Informal document GRSG-108-46
(108th GRSG, 4-8 May 2015,
agenda item 5)

Proposal for a draft Supplement to the 04 series of amendments to Regulation No. 46 (Devices for indirect vision)

Submitted by the expert from the Netherlands

Figure 4
Field of vision of Class I mirror Class I field of vision

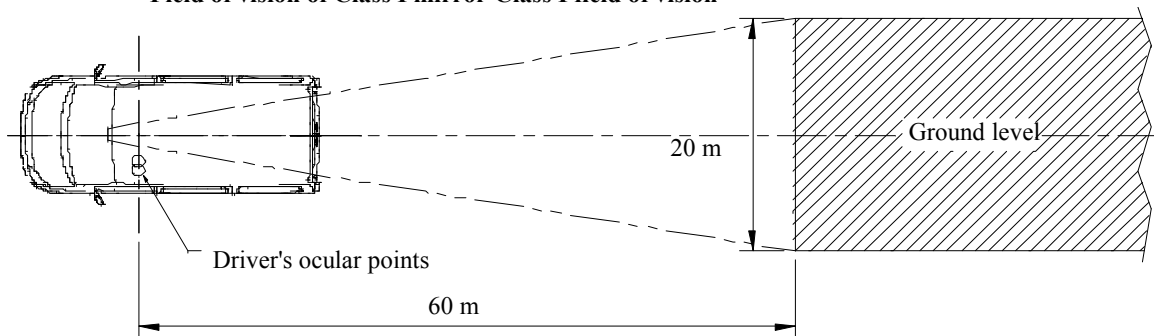
15.2.4.1. ~~Interior rear view mirror (Class I)~~ **Class I rear-view device**

The field of vision shall be such that the driver can see at least a 20 m wide, flat, horizontal portion of the road centred on the vertical longitudinal median plane of the vehicle and extending from 60 m behind the driver's ocular points (Figure 4) to the horizon.

Figure 5
Field of vision of Class II mirrors Class II fields of vision

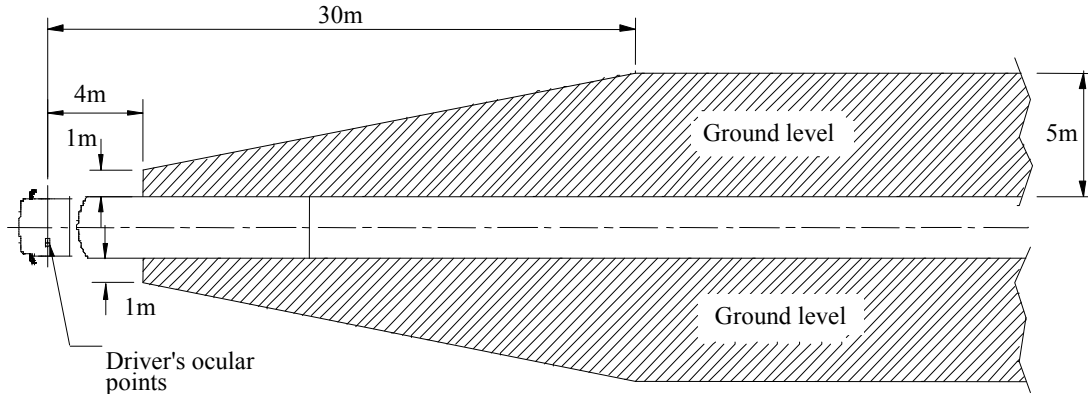
15.2.4.2. ~~Main exterior rear view mirrors~~ **Class II main rear-view device**

Figure 7
Field of vision of Class IV wide-angle mirrors Class IV fields of vision

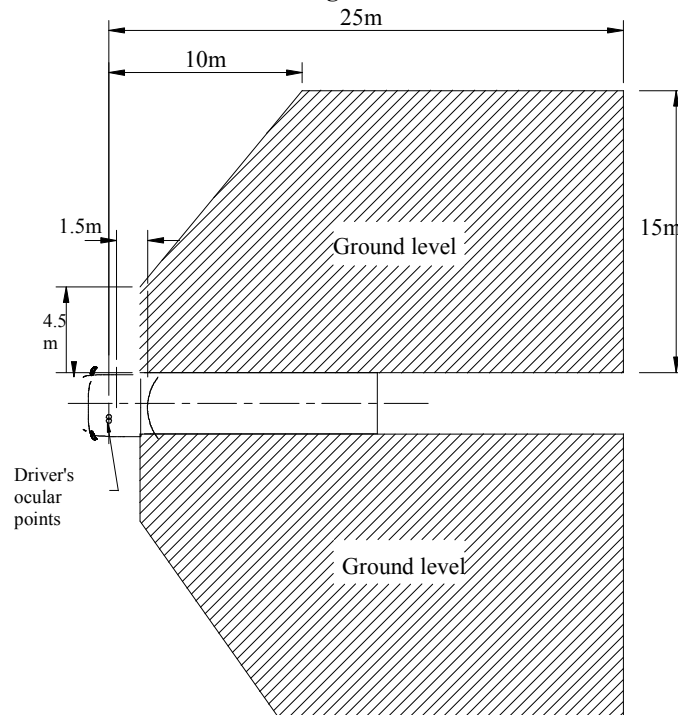
53. Paragraphs 15.2.3.1. and 15.2.3.2.
These paragraphs specify that the provisions on adjustment apply only to mirrors.
54. Paragraph 15.2.4.4.2.
Figure 7 has been corrected on the passenger's side so that the indicated dimensions are in correspondence with the front of the grey area.
